INFORMATION RECOMMENDED **MANDATORY****A. SUBJECT:**

Replacement of rubber oil hose at airplanes equipped with engine Rotax Type 914 Series.

B. AFFECTED AIRPLANES:

Fig. 1

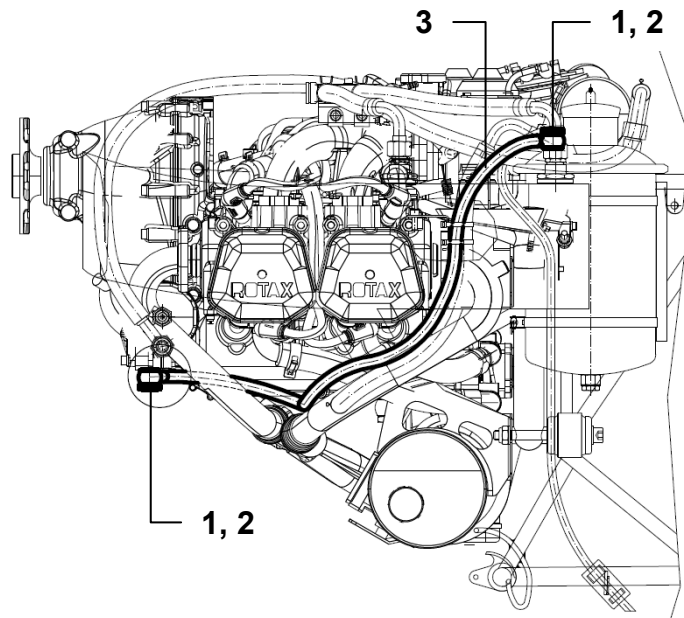
1. Remove the engine cowlings.
2. Remove banjo bolts (1), gasket rings (2) and original rubber oil hose (3) connecting the oil tank and the oil pump. Attention, there may be oil in the hose.

Fig. 2

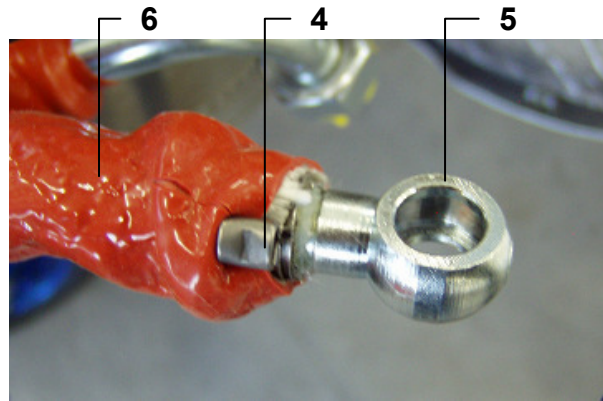
- Cut off the clamps (4), remove the banjos (5) and fire protection (6).

Fig. 3

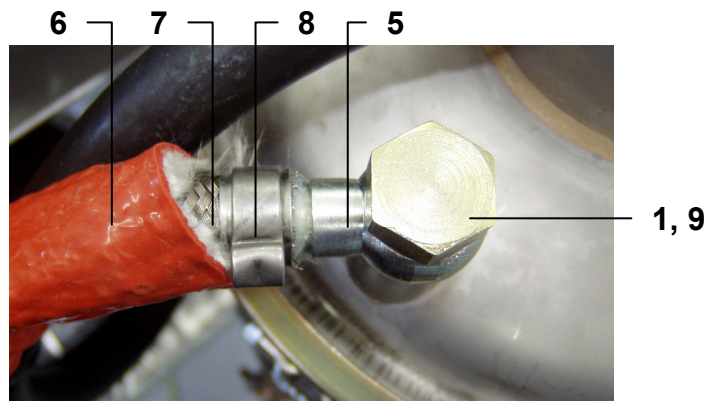
- Shorten the new PTFE oil hose (7) according to the original one and put on the fire protection (6). Check and clean the impurities in the PTFE oil hose as necessary. Put the clamps (8) and banjos (5) on the new PTFE oil hose (7) and connect it to the oil tank and oil pump by means of banjo bolts (1) and new gasket rings (9). Finalize the clamps (8).

Fig. 4

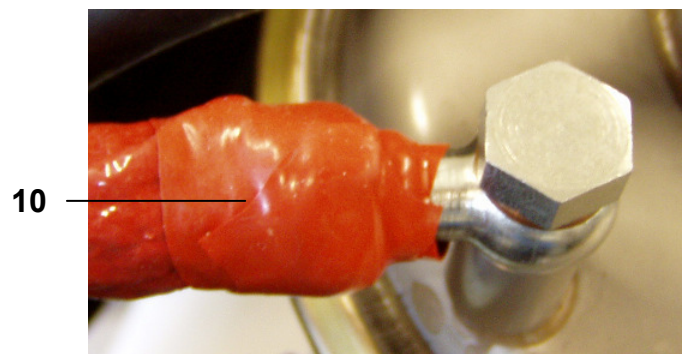
- Finalize the banjo bolts with 12 Nm torque. Seal the ends of fire protection by a fire protective tape (10). Attach the new oil hose in the engine compartment.
